1955 Corvette: Service Bulletin: Oil Level Gauge Dipsticks

Model and Year: 1955 Powerglide Transmission

Bulletin No: DR-181

POWERGLIDE TRANSMISSION DIPSTICK MARKINGS

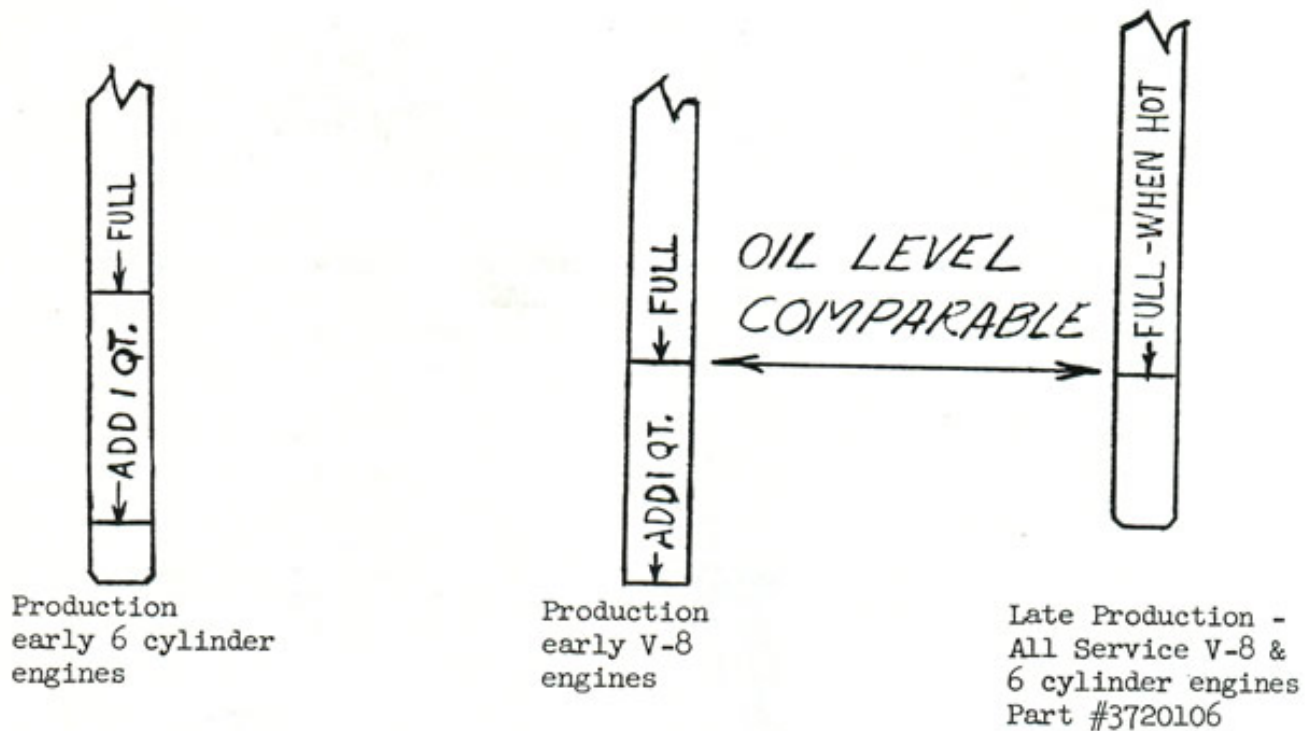
The following sketch shows the various Oil Level Gauge Dipsticks used with the 1955 Powerglide Transmission.

1. Engine should be idling.
2. Transmission control lever should be in the "N" position.
3. Transmission oil should be HOT.
4. Use the correct dipstick.
5. Check the level accurately.

Overfilling the transmission may cause lubricant loss at the Filler.
